**SECTION 00 90 01
BIDDING AND CONTRACT REQUIREMENTS
ADDENDUM NUMBER (5)**

Issued: April 30th, 2024

Re: ADDENDUM NUMBER (5) TO THE BIDDING DOCUMENTS FOR

**Peoria Park District
Golf Entertainment Facility Renovation an Addition
Architect's Project Number: 22-051**

SHEET TITLE:
**ONE-LINE DIAGRAMS
 AND DISTRIBUTION
 DETAILS**

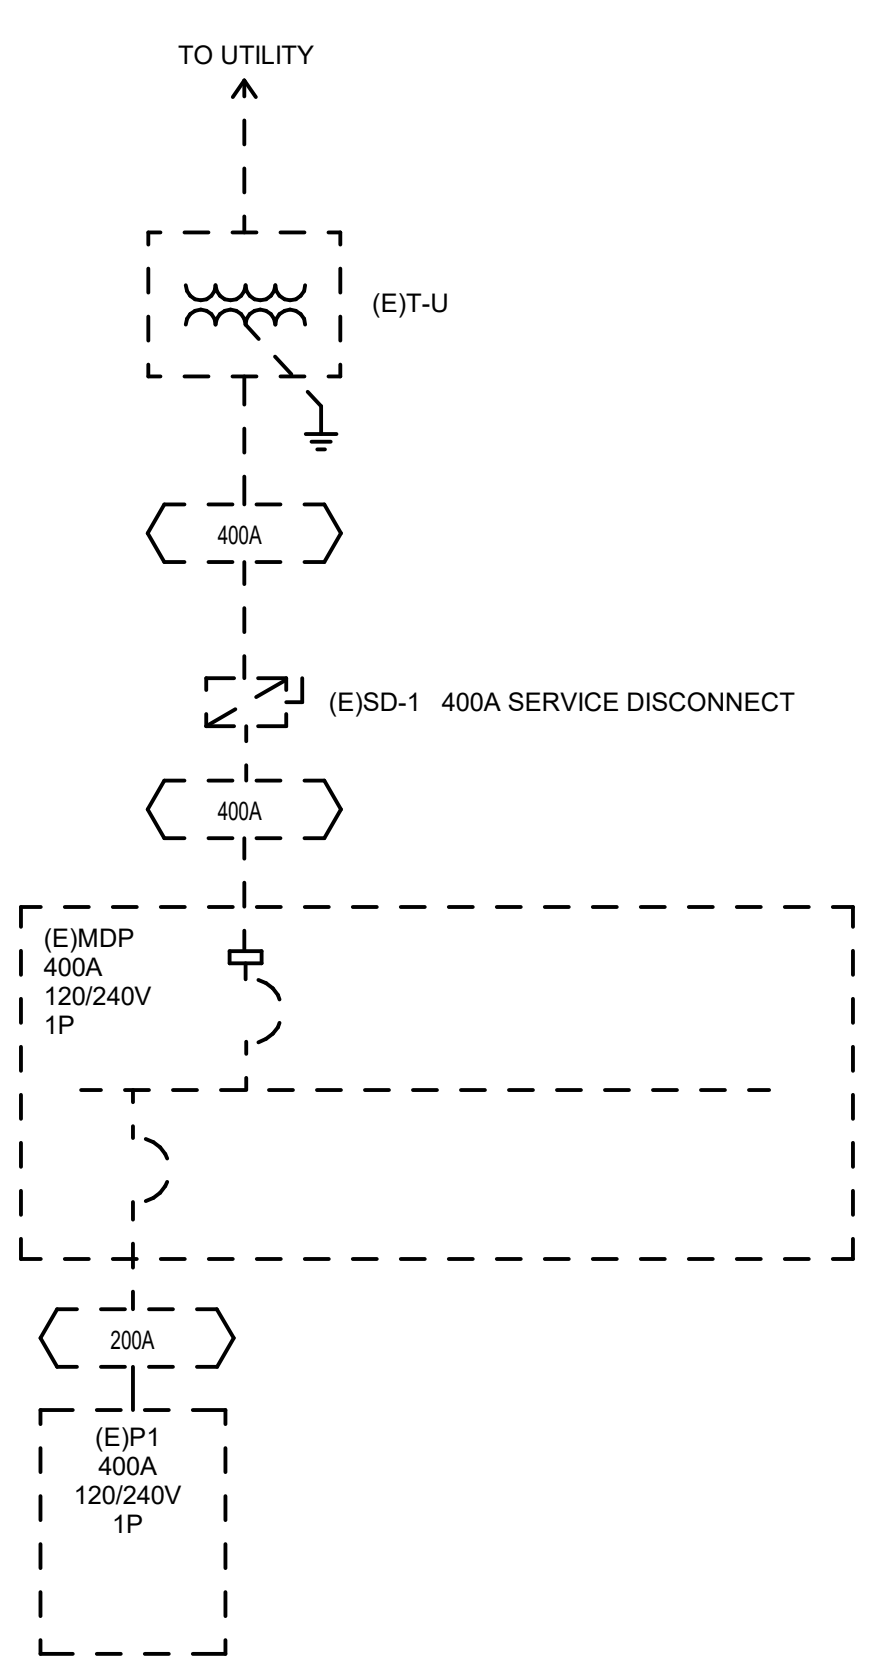
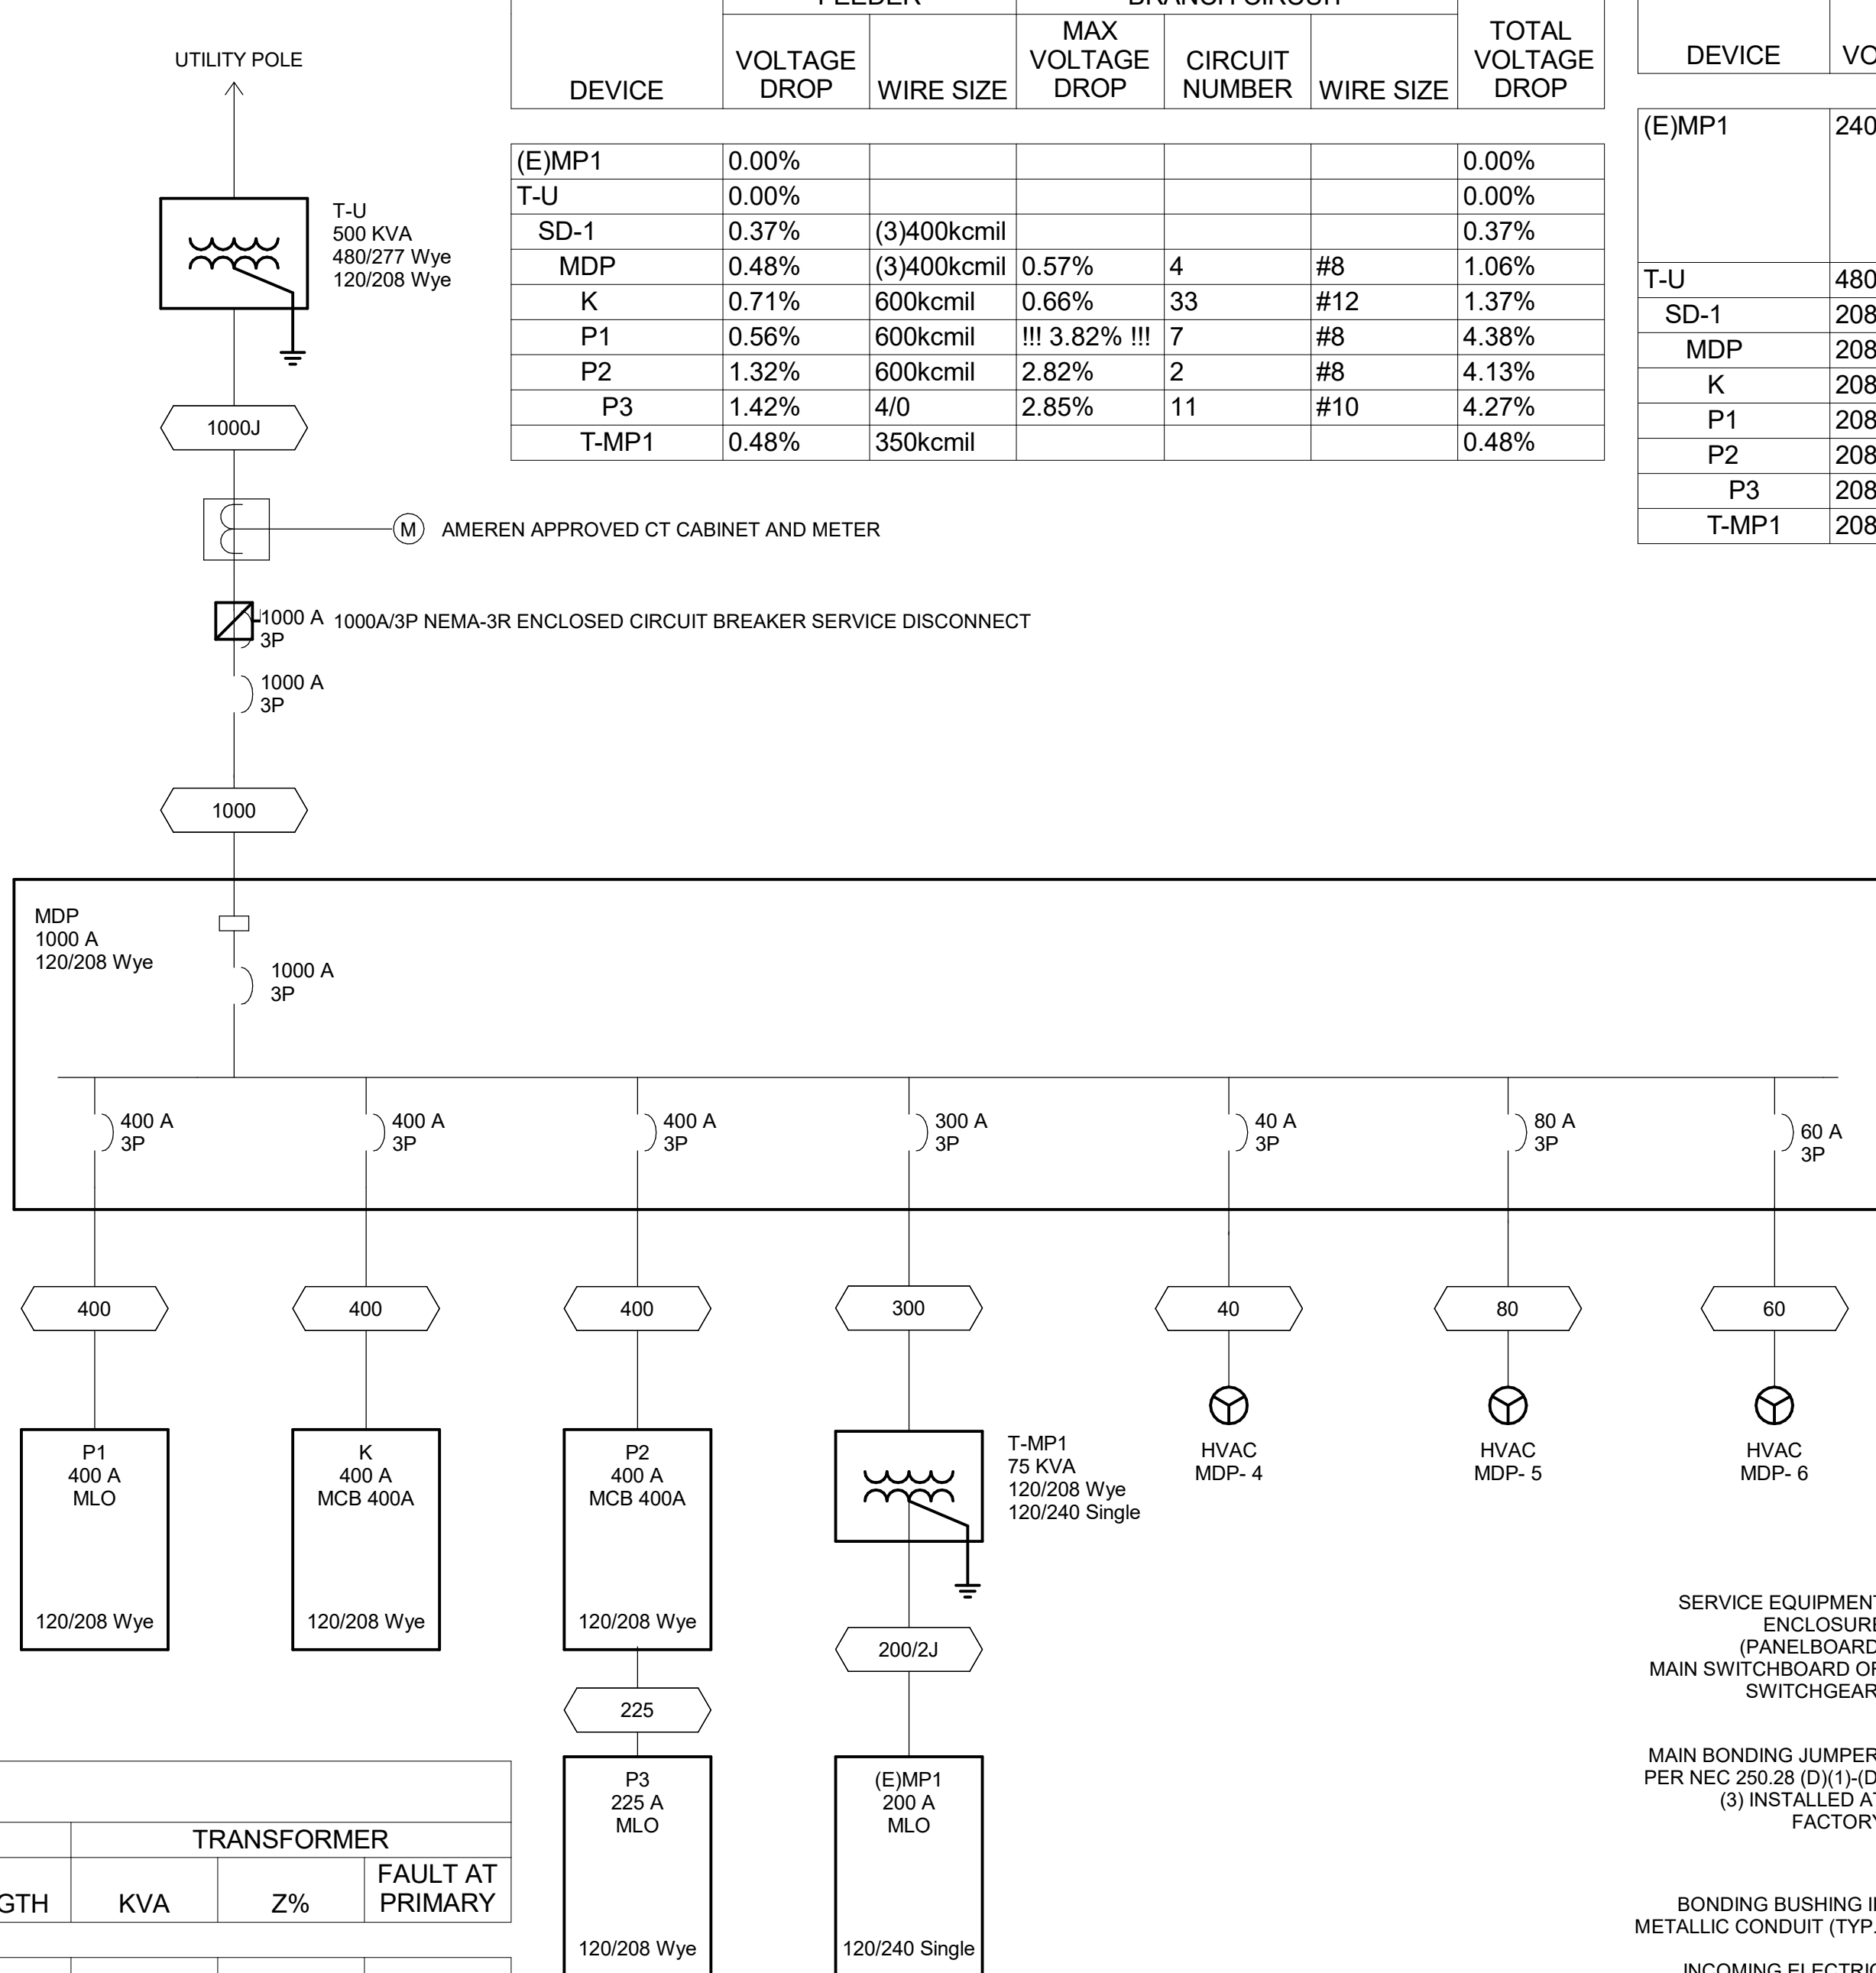
6. **5.** Drawing E2.0 – ONE-LINE DIAGRAMS AND DISTRIBUTION DETAILS
 - a. Revise equipment connection schedule to remove circuits for EF-113 and EF-204 as they will be circuited to a portion of the local lighting circuit.

5. Drawing E2.0 – ONE-LINE DIAGRAMS AND DISTRIBUTION DETAILS
- a. Revise equipment connection schedule to remove circuits for EF-113 and EF-204 as they will be circuited to a portion of the local lighting circuit.

SHEET TITLE:
TELECOMM. RISER, SCHEDULE, AND NOTES

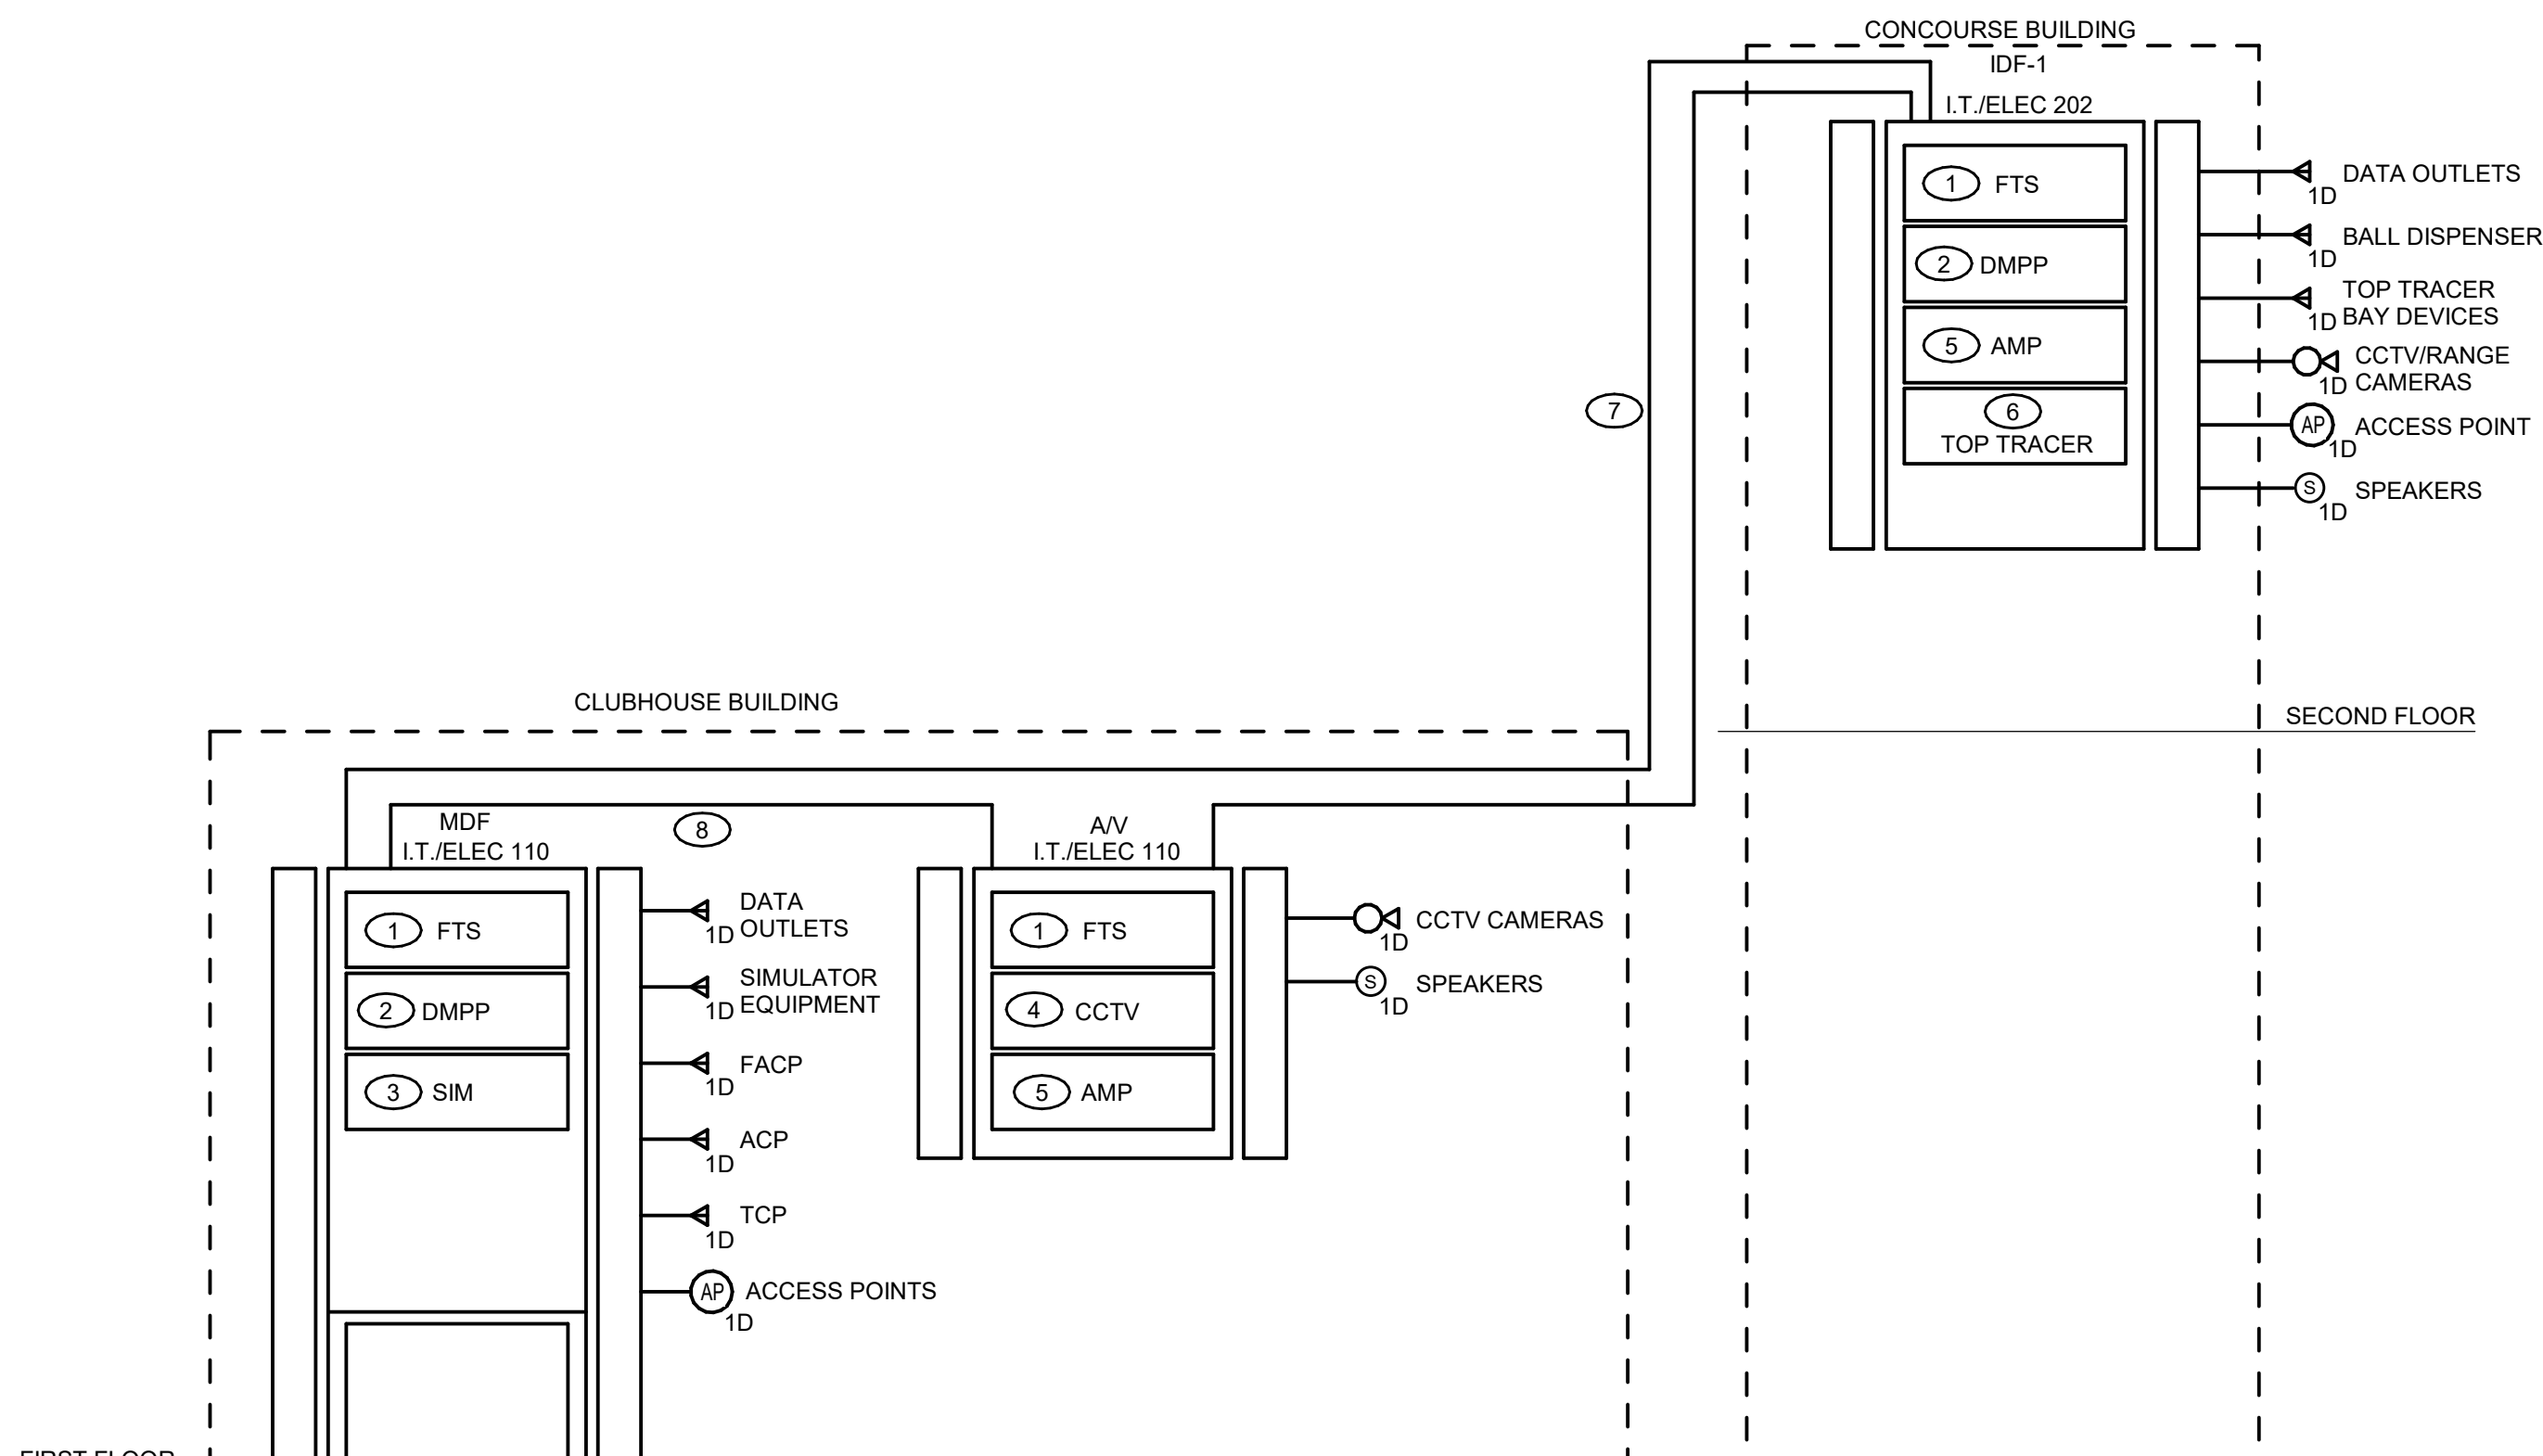
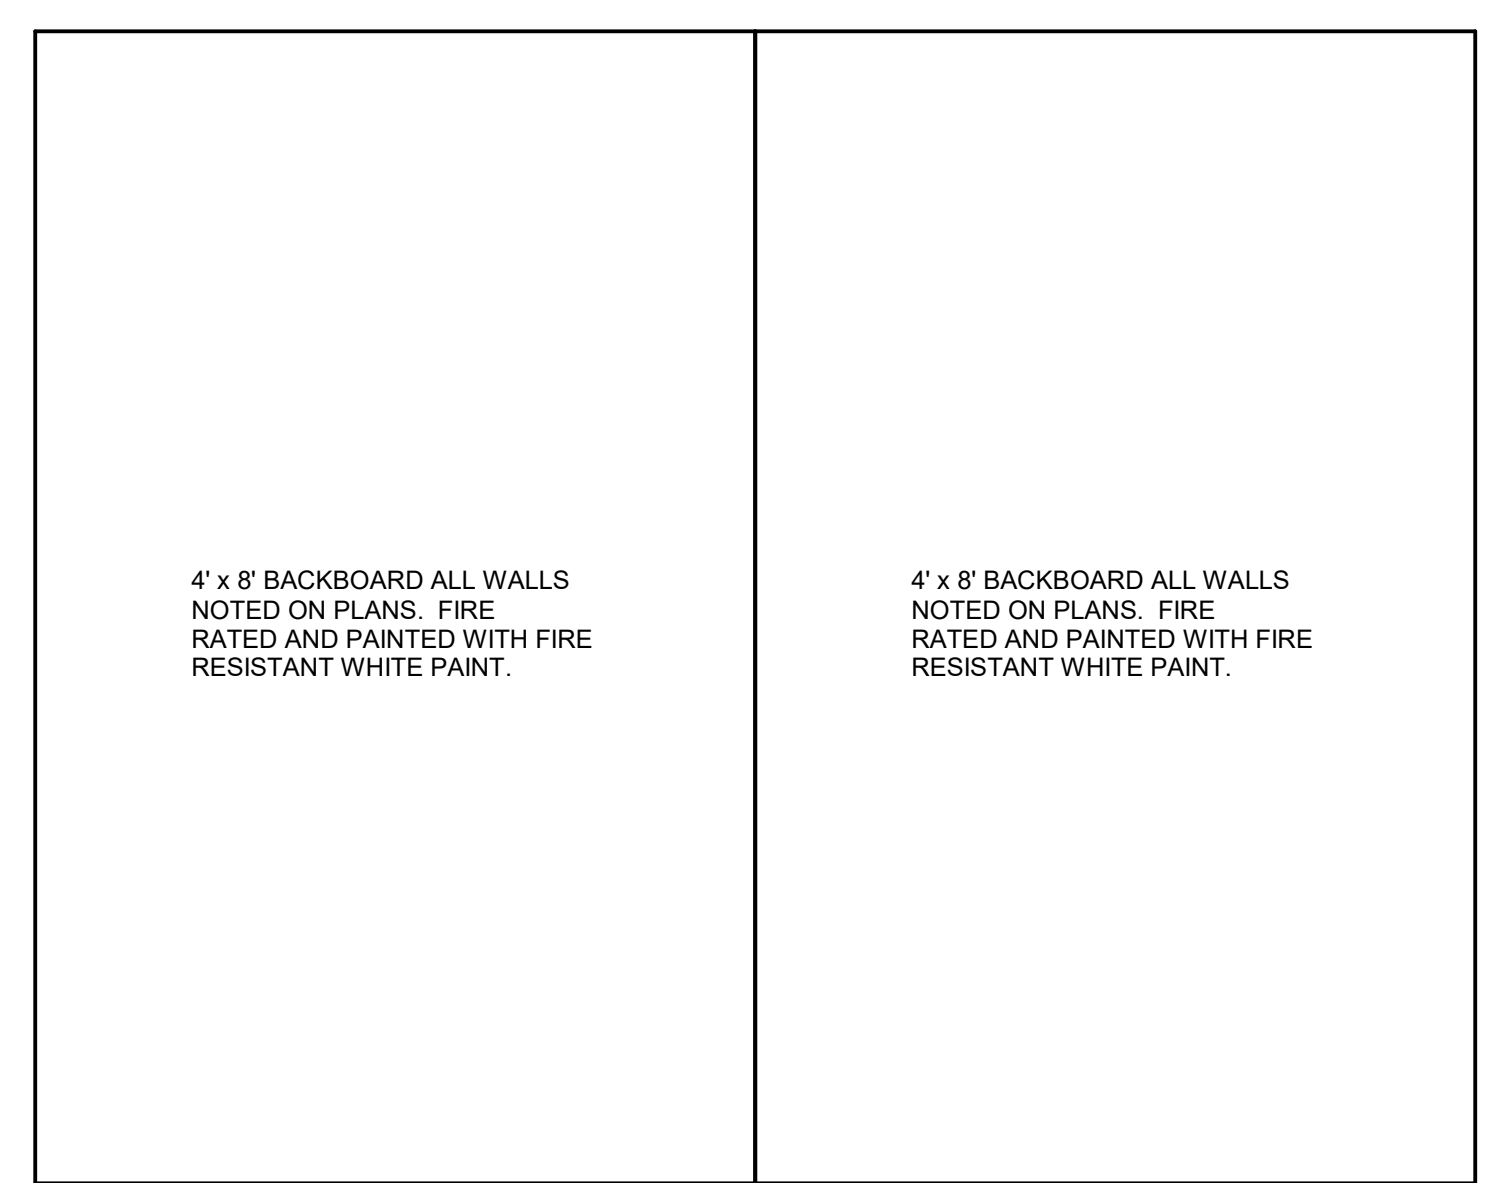
7. Drawing E4.1 – TELECOMM. RISER, SCHEDULE, AND NOTES
 - a. Revise Telephone and Data Equipment Schedule to remove reference to OSF projects and standards.

6. Drawing E4.1 – TELECOMM. RISER, SCHEDULE, AND NOTES
- a. Revise Telephone and Data Equipment Schedule to remove reference to OSF projects and standards.
